PROJECT: Advanced Healthcare of Las Vegas II

CITY OF LAS VEGAS INTER-OFFICE MEMORANDUM

Drainage Study for:

Advanced Healthcare of Las Vegas II

EXHIBIT FOR AHC FACILITY

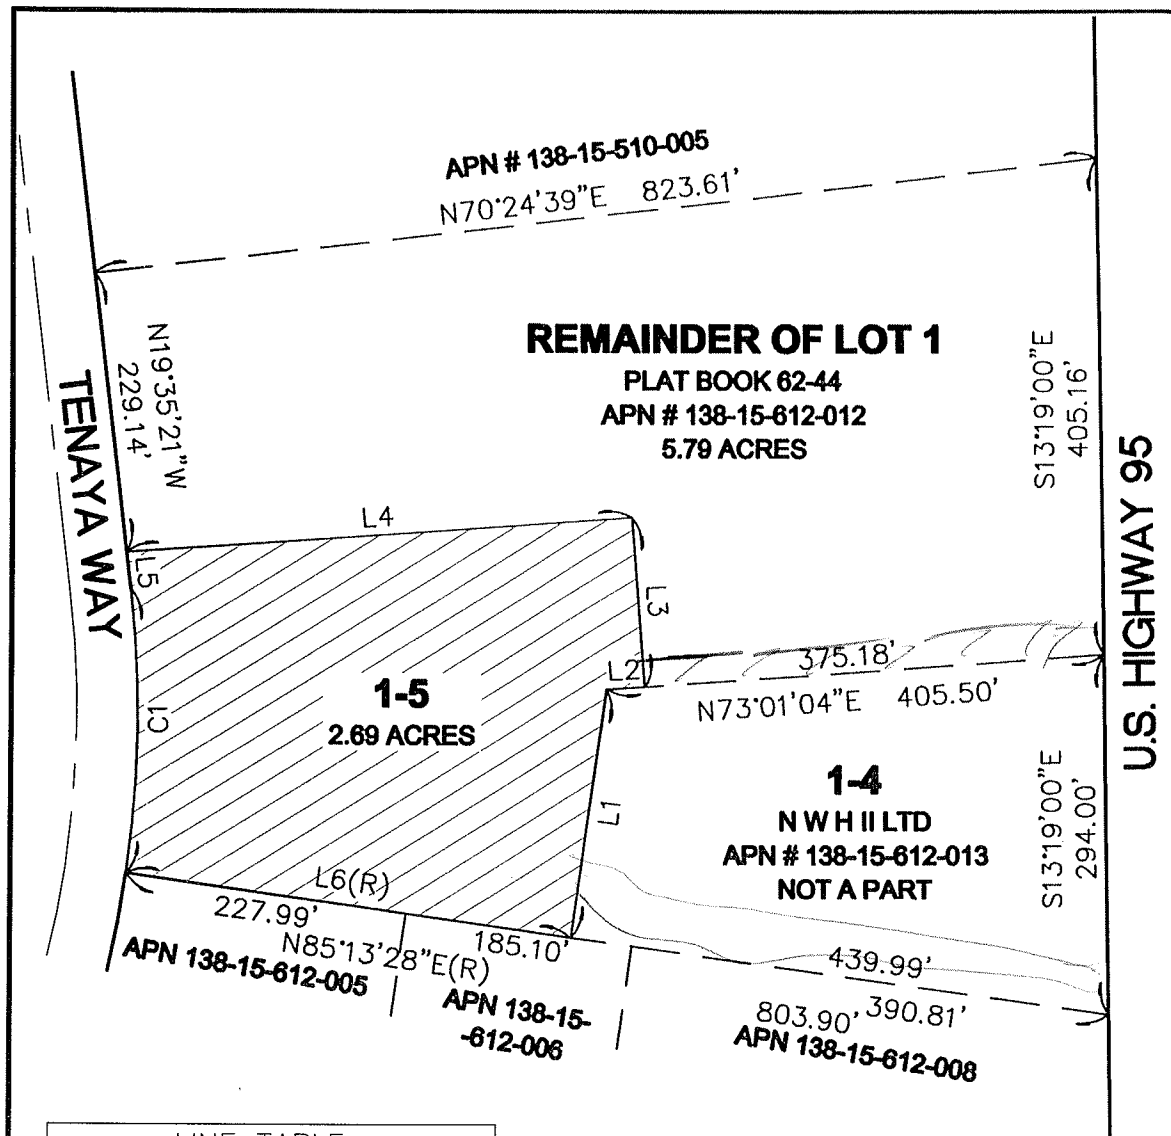
2. Provide a copy of the Record of Survey for verification of the subject property being parceled out from the *City Parkway V Inc.* ownership.
3. The subject development proposes to discharge onsite drainage into adjacent properties at two locations: one at the northeast corner and the other at the southeast corner of the subject site. The northeast corner discharge is not ideal for it will burden the adjacent property to have a drainage easement in the middle of their land, ie, they cannot best utilize their land in the future. A more beneficial point of discharge is to shift the proposed point to the first angle point to the south.

Obtain a minimum 10'-wide public drainage easement (privately maintained) from the adjacent property owner prior to the final approval of the drainage study.

4. For the southeast discharge point, obtain a minimum 10'-wide public drainage easement (privately maintained) from the adjacent property owner prior to the final approval of the drainage study.

DETAIL SHEET

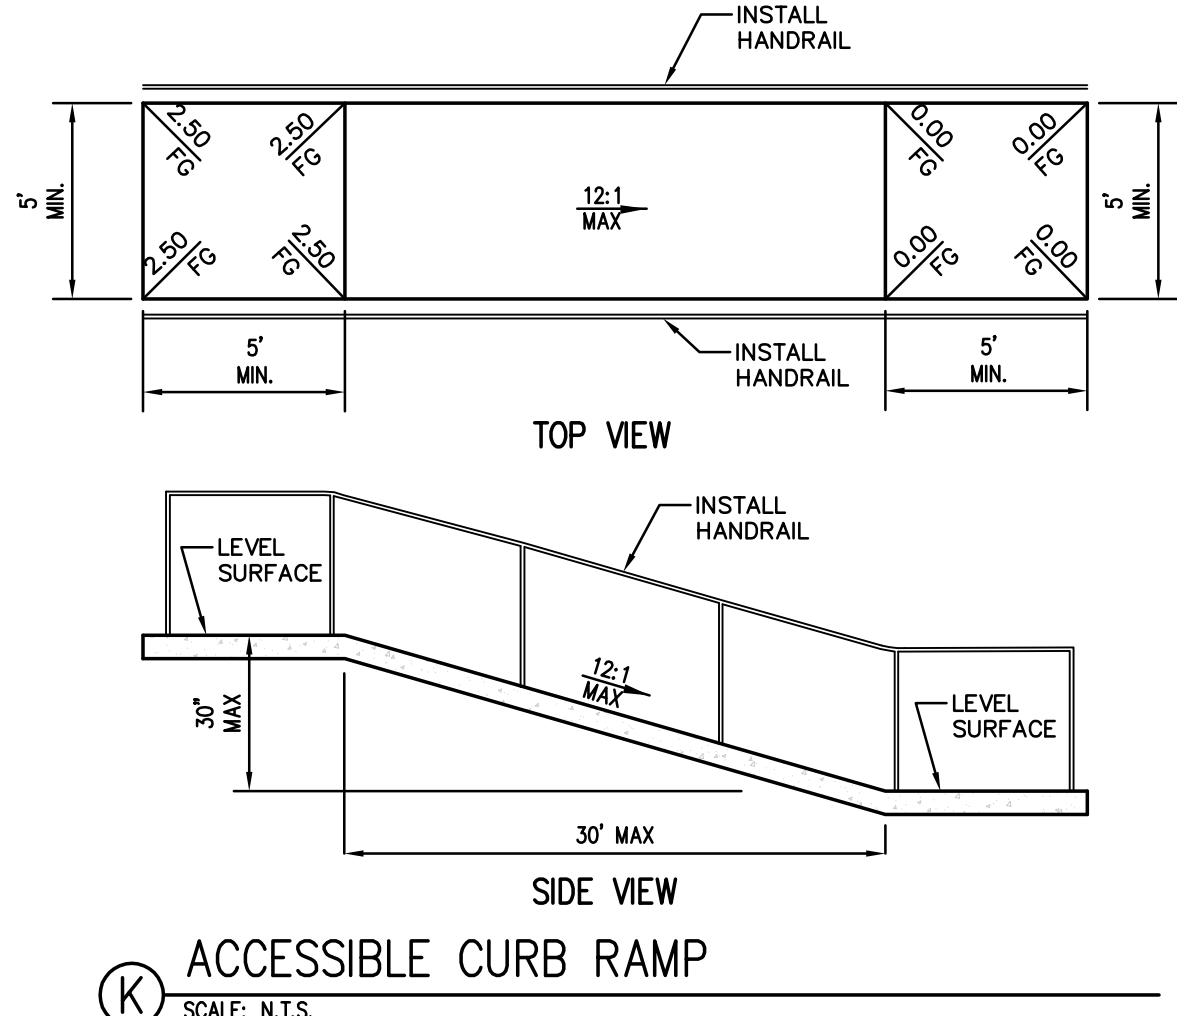
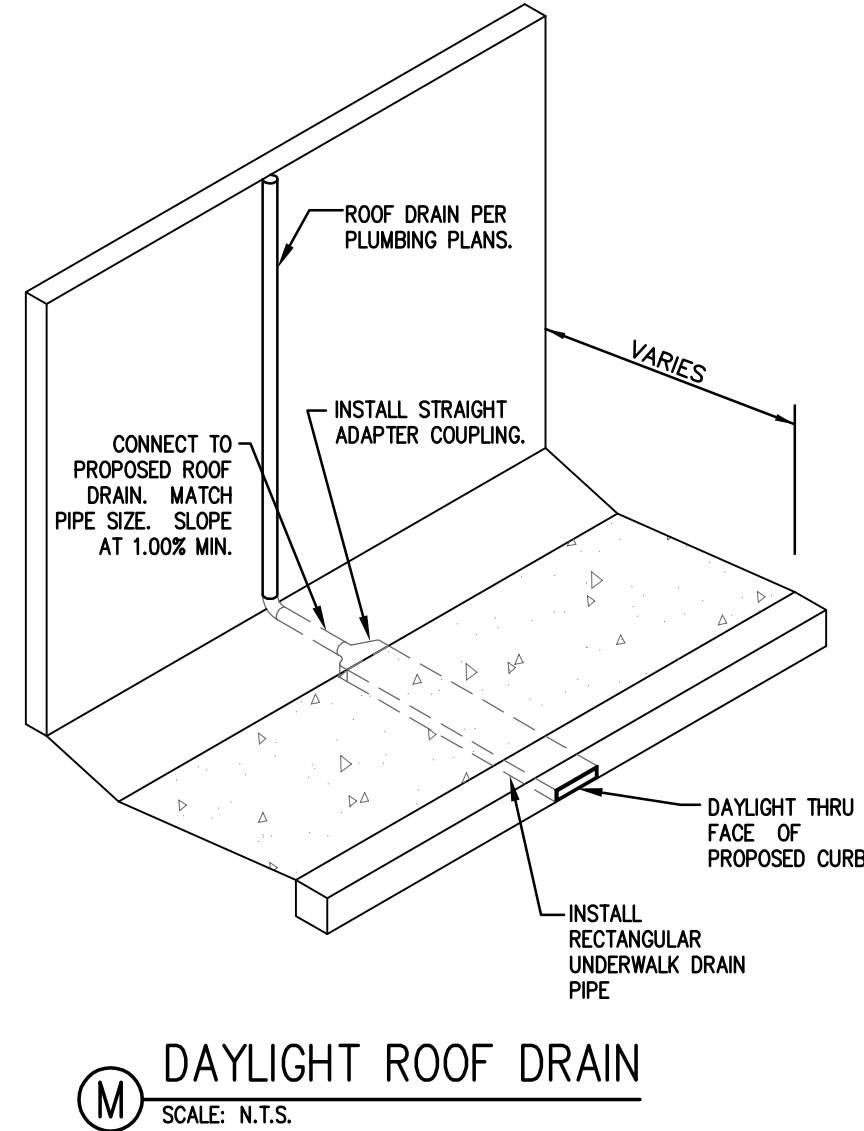
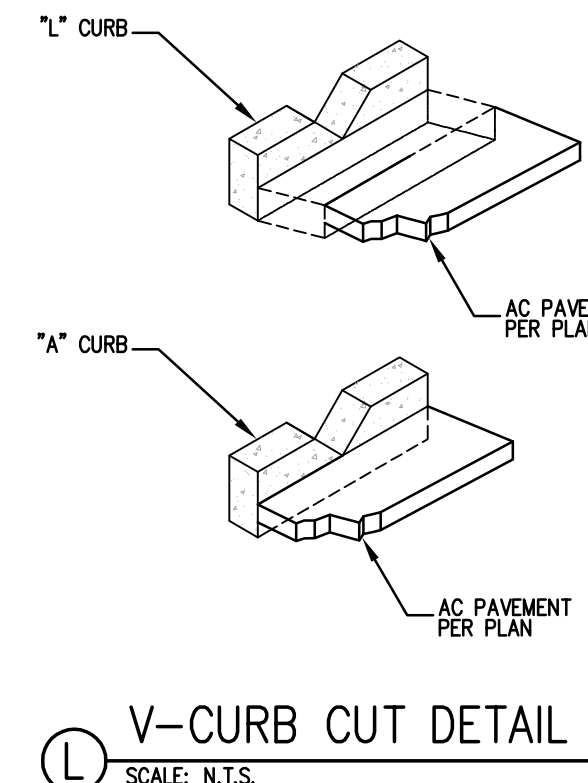
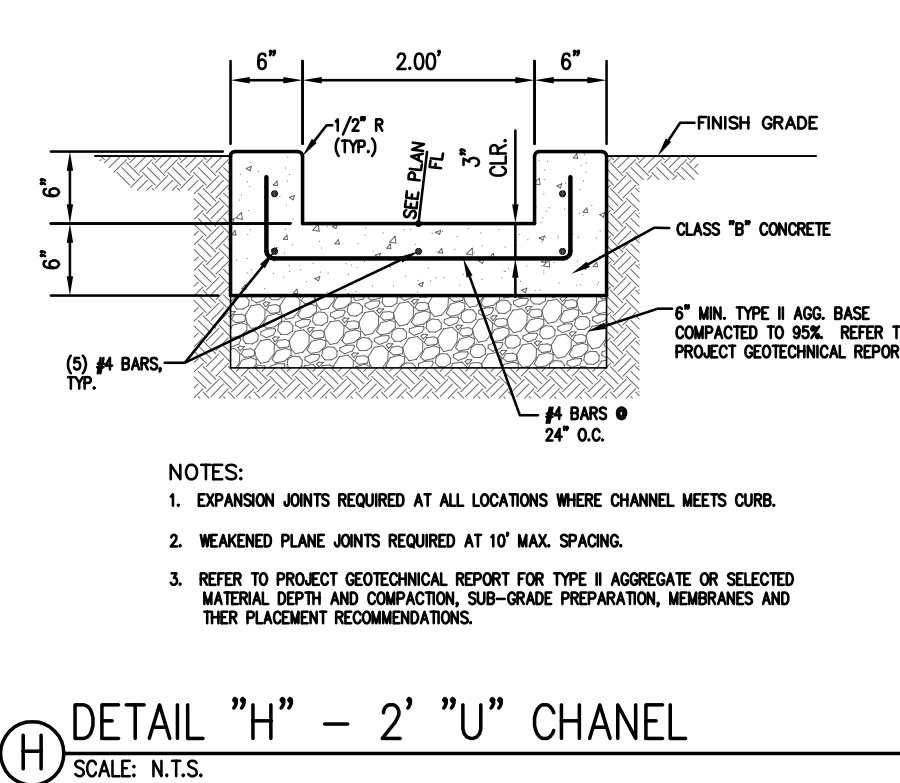
5. **Section C/4** shows that drainage behind the retaining wall discharge into the adjacent property to the east. Provide a swale to contain the drainage onsite. Show a flow line on the grading plan with elevations at regular interval to verify the detail as such.
6. **Section D/4** indicates that no flow is directed onto the adjacent property to the east. Provide a scarp along the east boundary with flow line elevations at regular interval on the grading plan to show as such.
7. Construction Note #19 (Construct Sidewalk Underdrain) cannot be located anywhere on the grading plan. Please clarify in the next submittal.
8. Label an existing storm drain in *Tenaya Way* with *City of Las Vegas* recorded drawing number.
